Our ref: DOC20/1016548

Your ref: SSI-9487

### **Inland Rail Narromine to Narrabri – Environmental Impact Statement**

Attachment A – BCS's Recommendations

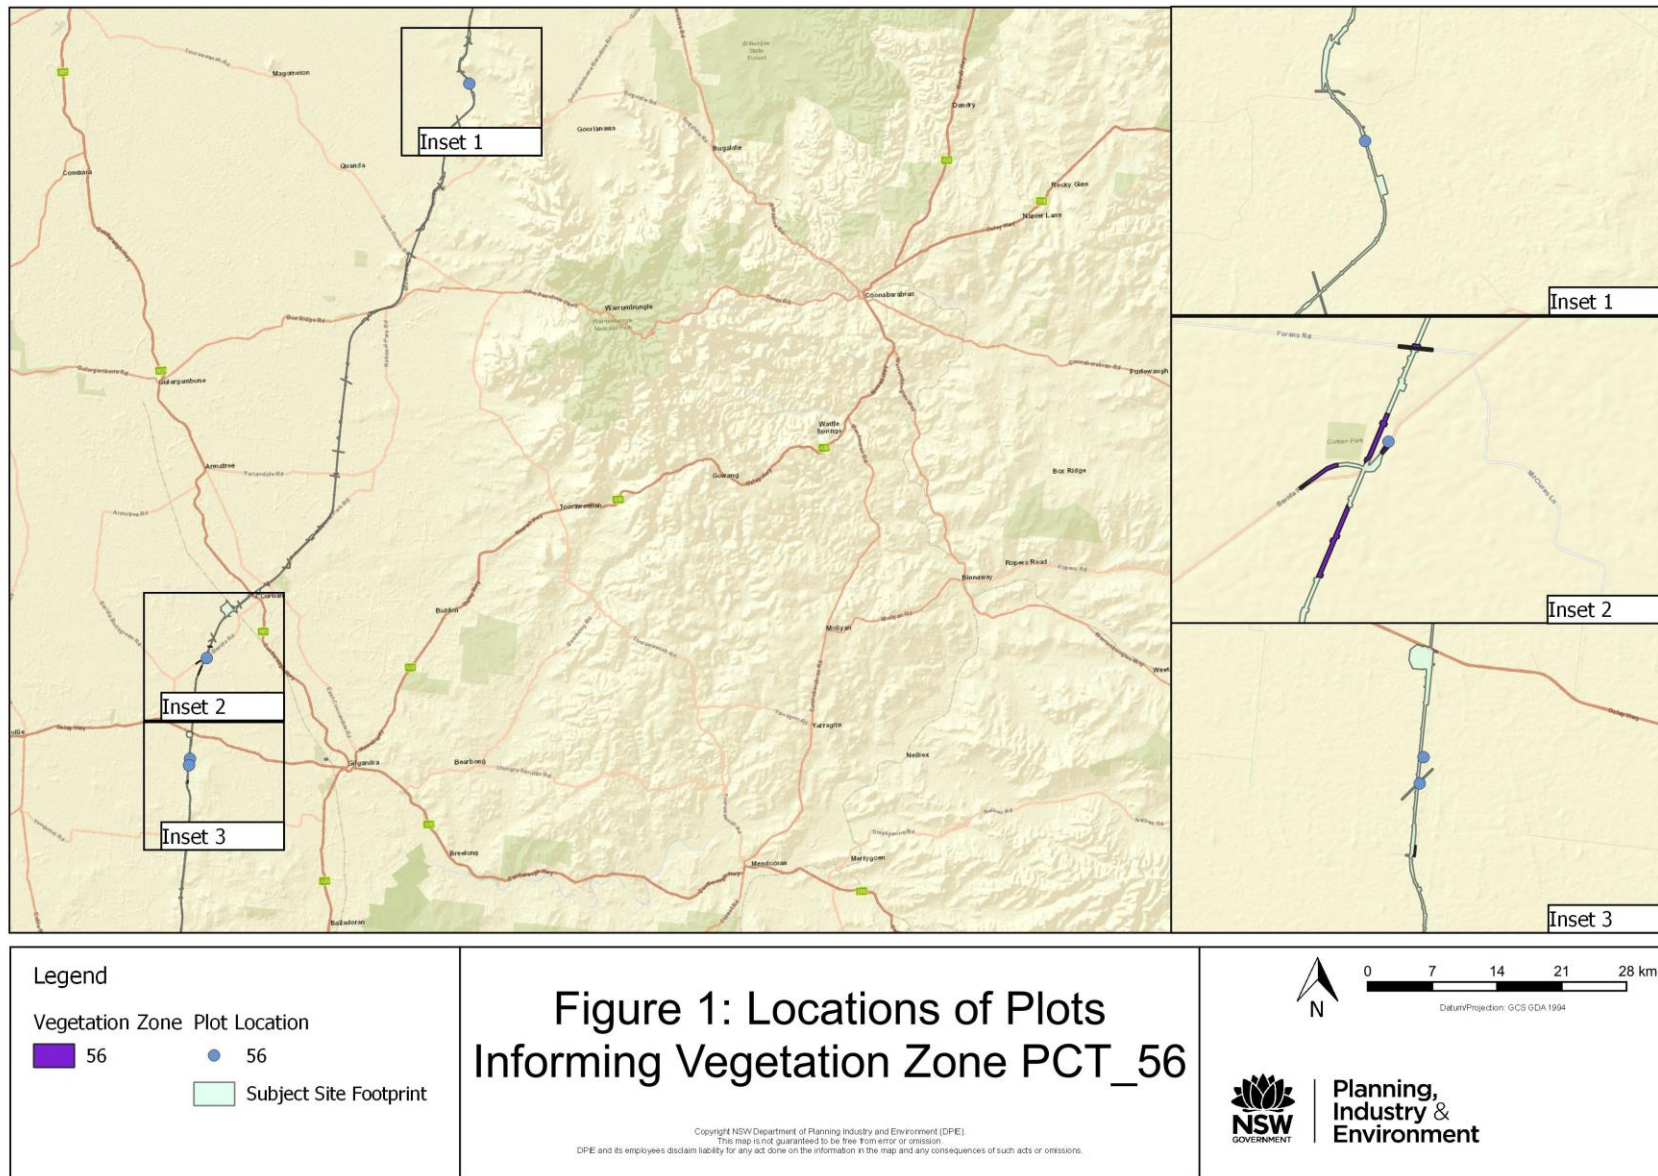
As an example, the vegetation integrity score for PCT 56 is informed by 4 vegetation plots, one plot undertaken north-west of Warrumbungle National Park and a cluster of three plots, more than 50 kilometres away, west of Gilgandra (see Figure 1 in this response). The condition state and naturally occurring variability across this representation of PCT 56 has the potential to differ between these two locations as a response to different land management and disturbance history and unique environmental variables present at each location including (but not limited to) the relative rainfall, soil type and geology.

BCS has reviewed a sample of vegetation zones mapped within the subject site against the relative location of individual vegetation plots which have been used to inform that zone's vegetation integrity score. It was found that some vegetation zones were being informed by plots which were located a significant distance from the nearest equivalent vegetation zone. As an example, a vegetation integrity plot undertaken for PCT 244 was located south west of Narrabri, however, the closest vegetation patch of PCT 244 mapped within the subject site occurs west of

BCS proposes to liaise with the proponent on both matters and provide further advice regarding each vegetation zone which may require additional vegetation plots or where current plot locations may be inappropriate. It is acknowledged that assessing the project per subregion (see Issue 3 in this response) and the additional plots that were undertaken in spring 2020 (section 3.4.5 of the BDAR) may further alter the representativeness of plots across the vegetation zones.

- 7.1 Liaise with BCS on vegetation zones to ensure plot locations and number of plots undertaken are adequate and appropriate along the length of the project.

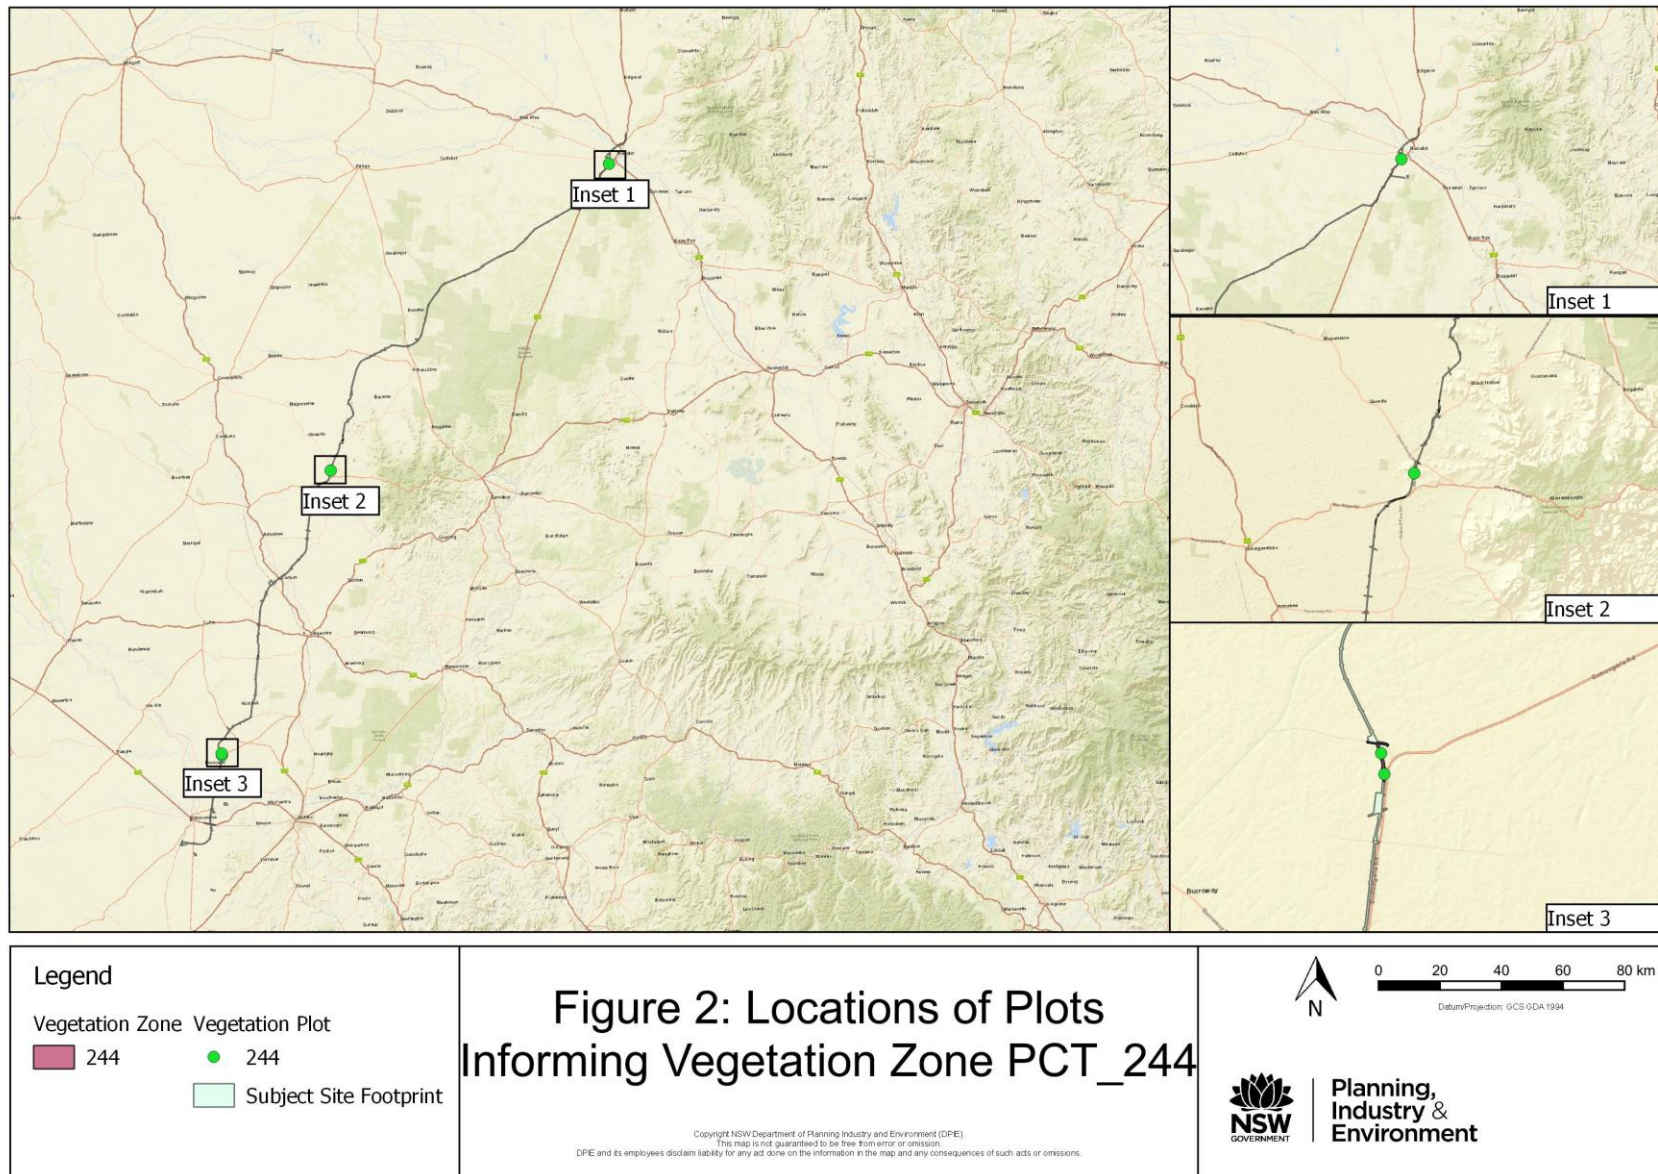
Black Hollow, approximately 120 kilometres to the south west of this plot (see Figure 2 in this response).
